CITY OF LA VISTA
MAYOR AND CITY COUNCIL REPORT
MARCH 16, 2021 AGENDA

Subject:	Type:	Submitted By:
PLANNED UNIT DEVELOPMENT ZONING OVERLAY AND SITE PLAN – LOTS 2 AND 3	RESOLUTION ◆ ORDINANCE RECEIVE/FILE	CHRISTOPHER SOLBERG DEPUTY COMMUNITY DEVELOPMENT DIRECTOR

**CITY OF LA VISTA
PLANNING DIVISION
RECOMMENDATION REPORT**

RE: Planned Unit Development – Initial Review
TNT Holdings

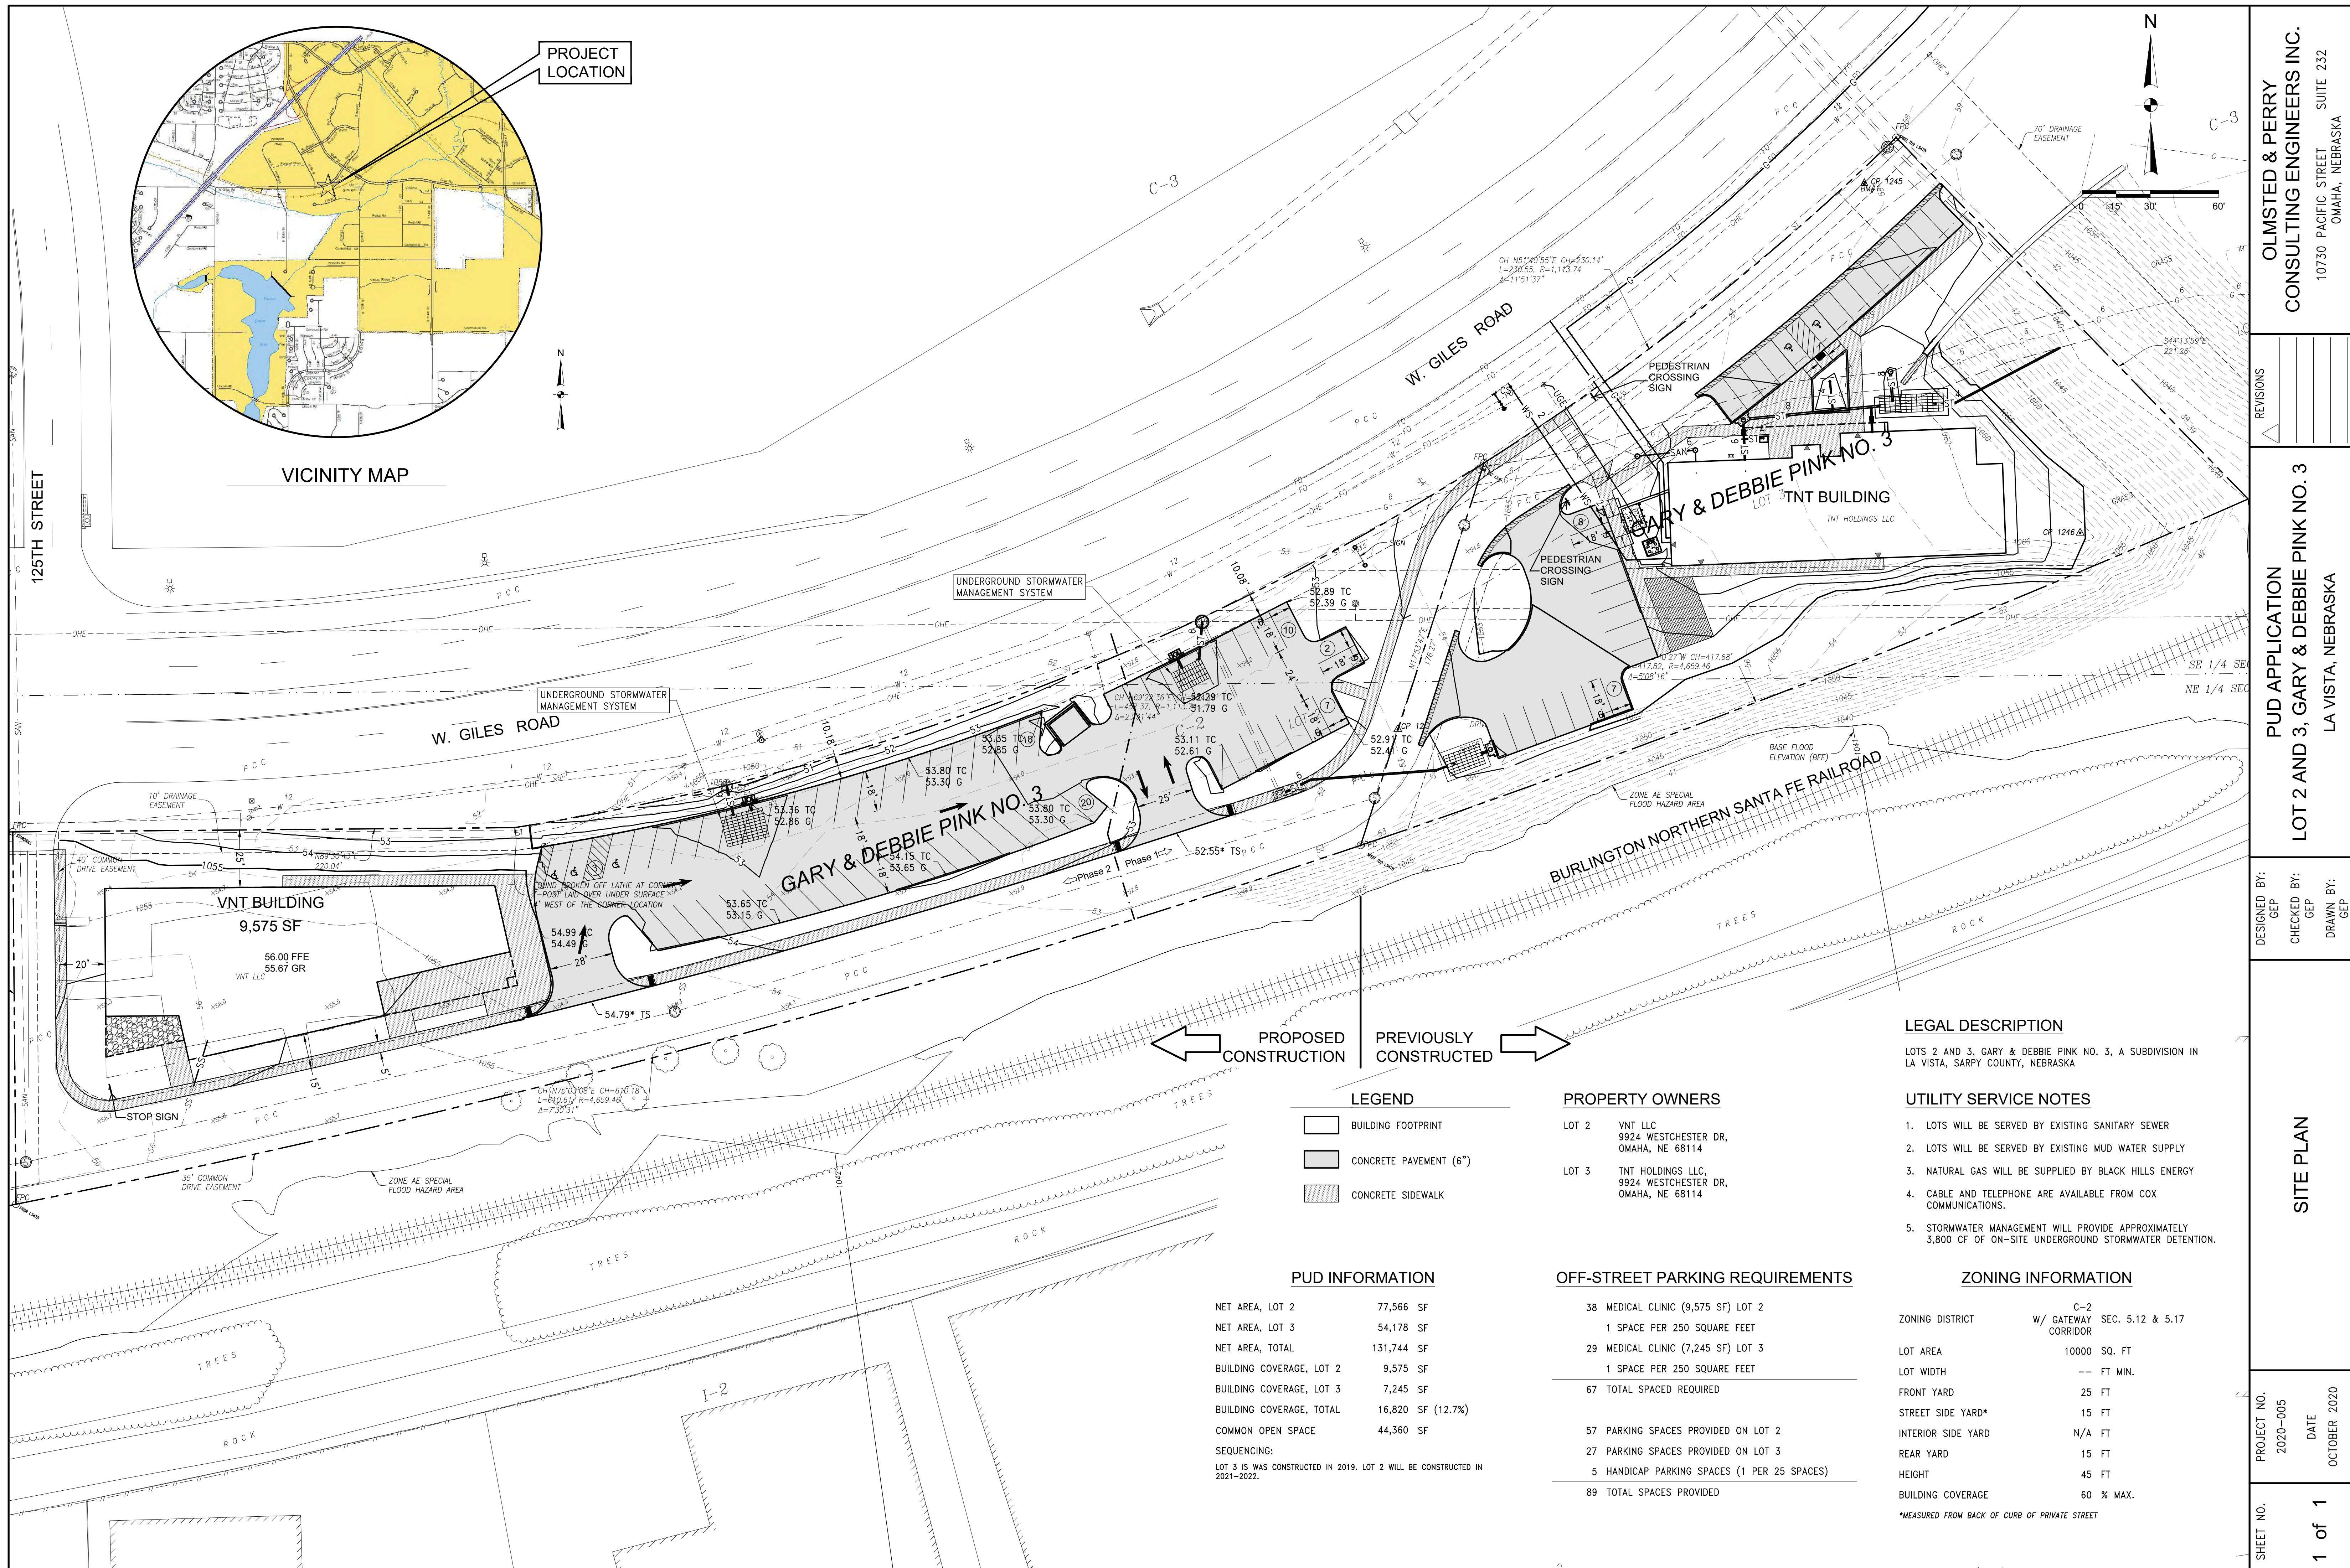
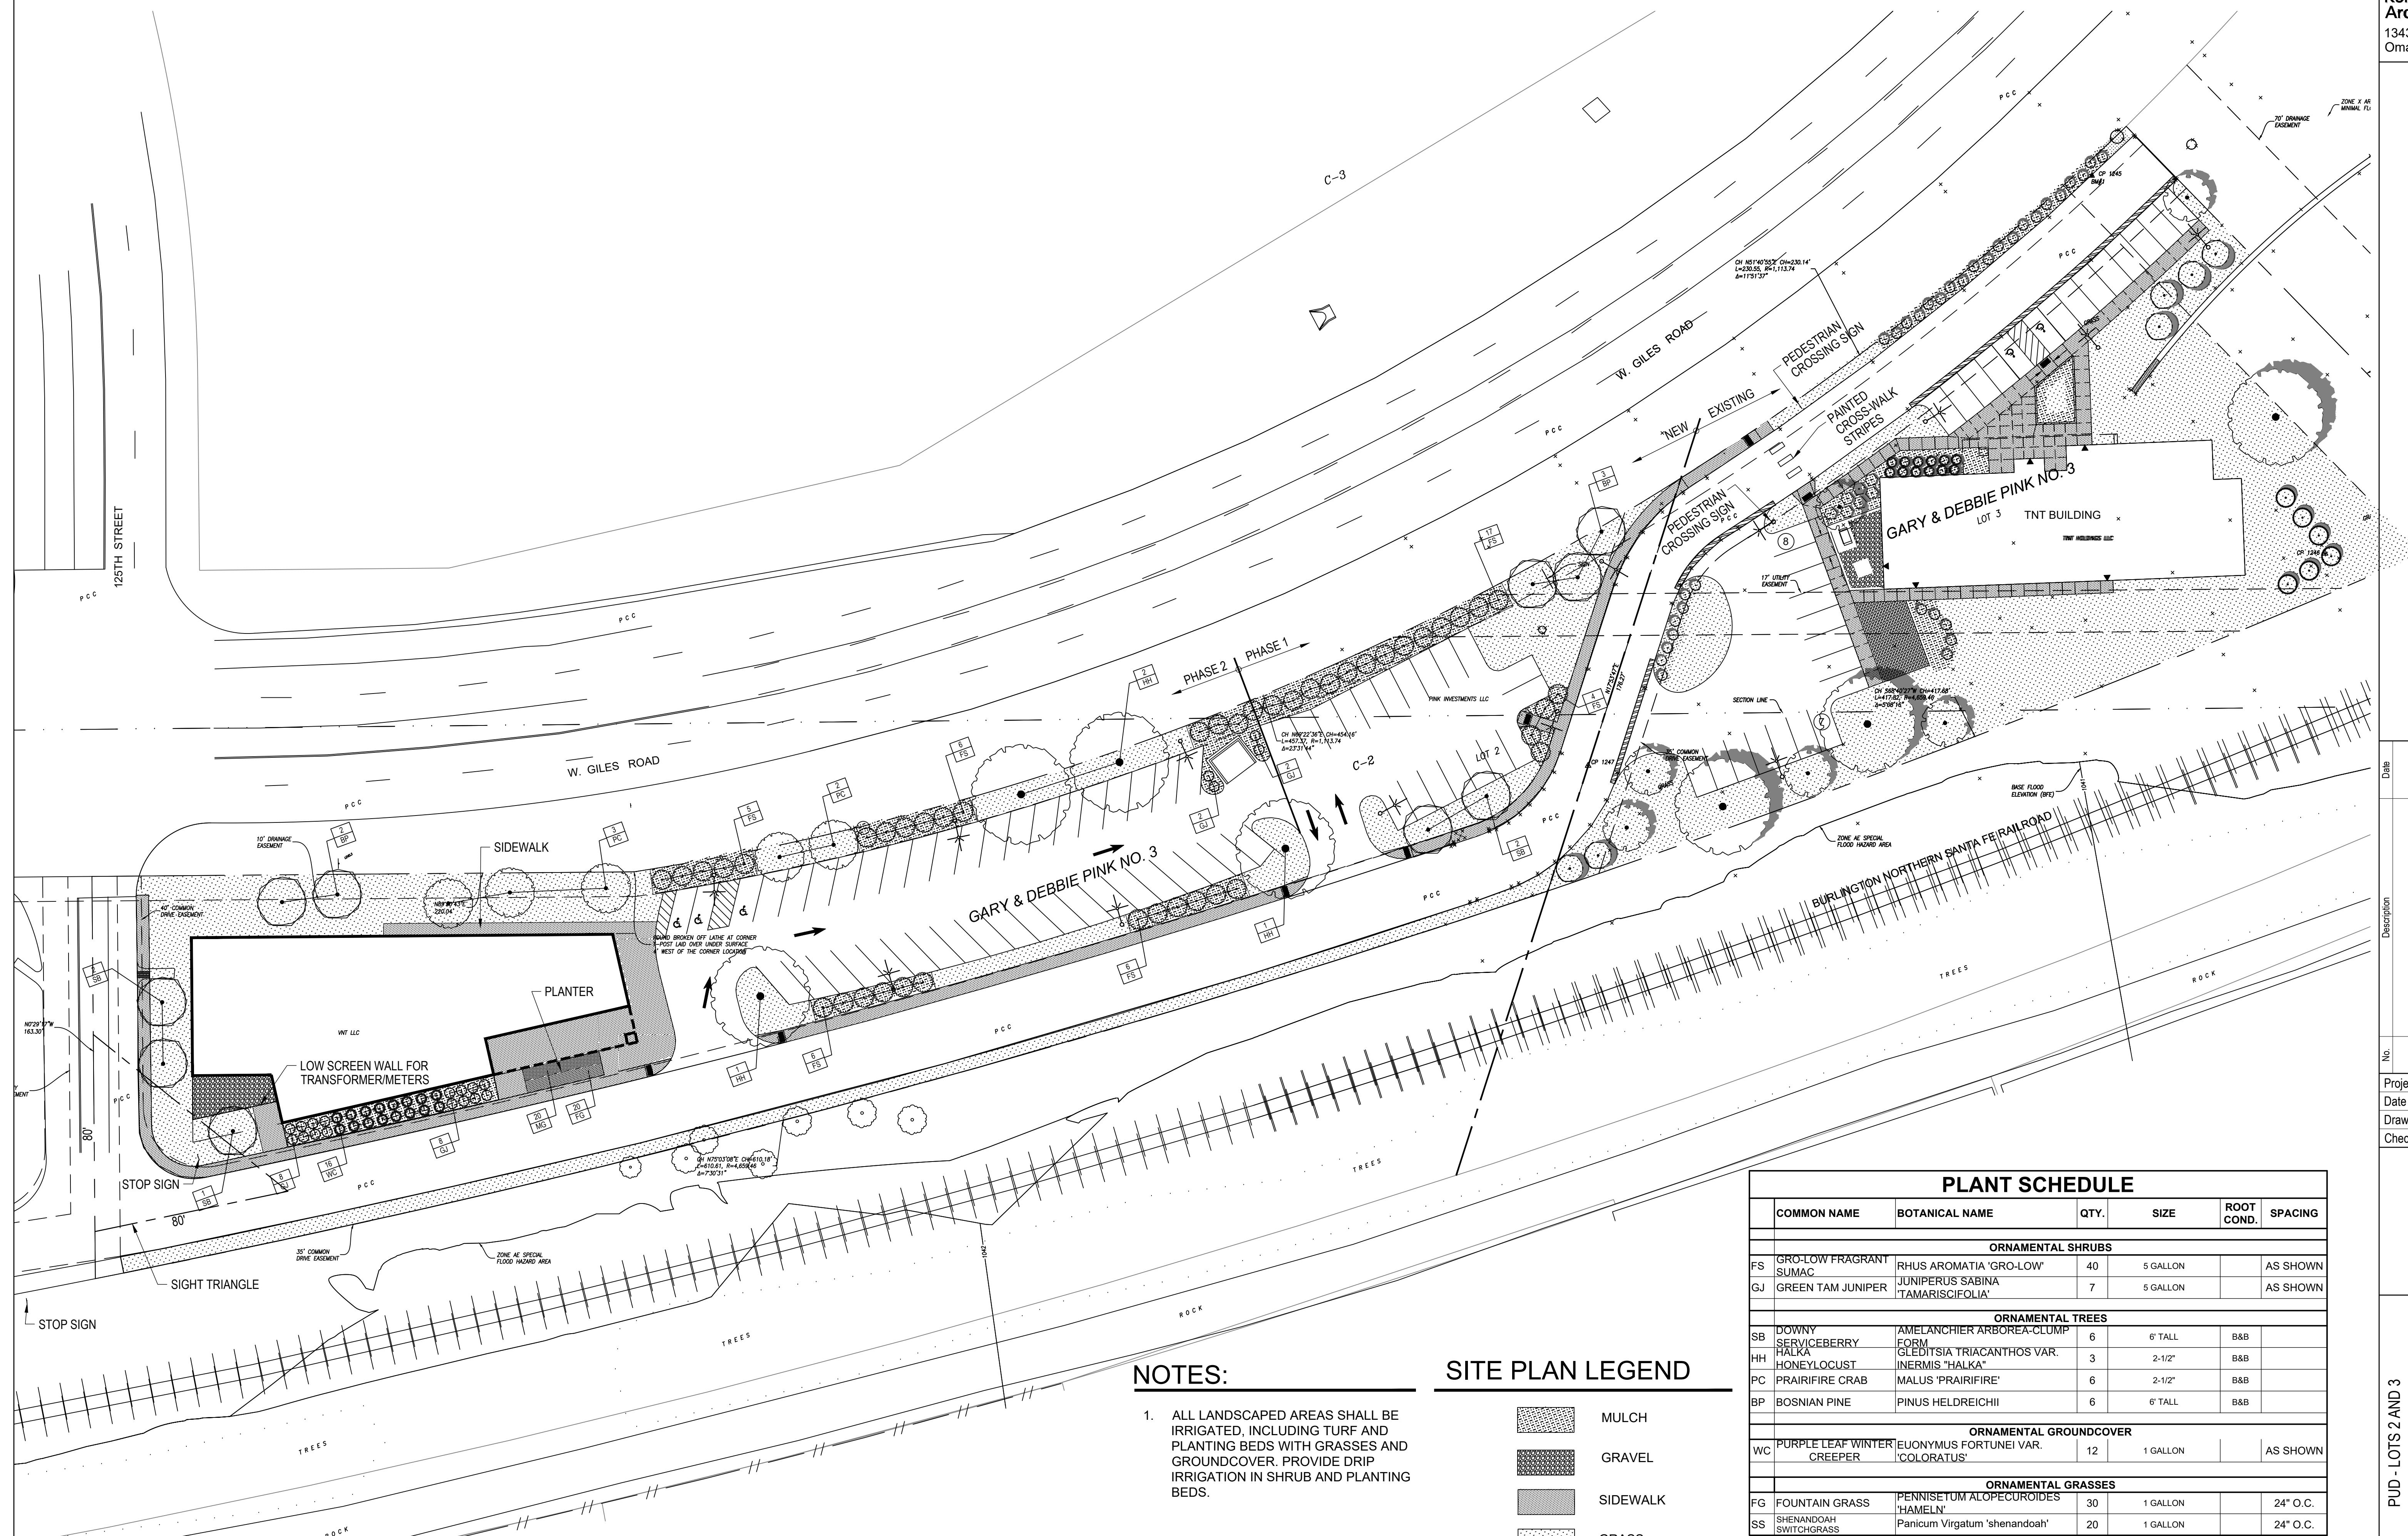
1. LS-100 Landscaping Plan:
 - a. See section 7.17.03.07 of La Vista Zoning Ordinance. All commercial office and industrial developments...shall provide perimeter landscaping to include a min. (1) tree for each forty (40) lineal feet of street frontage. Please verify and indicate on the drawing that the plan complies with this ordinance.

- b. See section 7.17.04.01 Screening Requirement of La Vista Zoning Ordinance. Parking areas abutting a public right-of-way are required to be screened from grade to a height of three feet. The trees and bushes indicated as a buffer between the public right-of-way and the parking are deciduous and will likely not have canopy to provide screening below 3 foot. Solid fences, walls, berms, hedges, shrubs, or evergreen trees are allowed by the ordinance. Please revise to show compliance with the ordinance.

- c. See Section 4, III, F, of the La Vista Gateway Corridor District Design Guideline. This guideline also requires natural undulating landscape forms. Avoid consistent straight-line plantings.

- d. See section 4, III, K. Storm water management is to be integrated into the site and landscaping. Please show how this will be integrated in your plan.
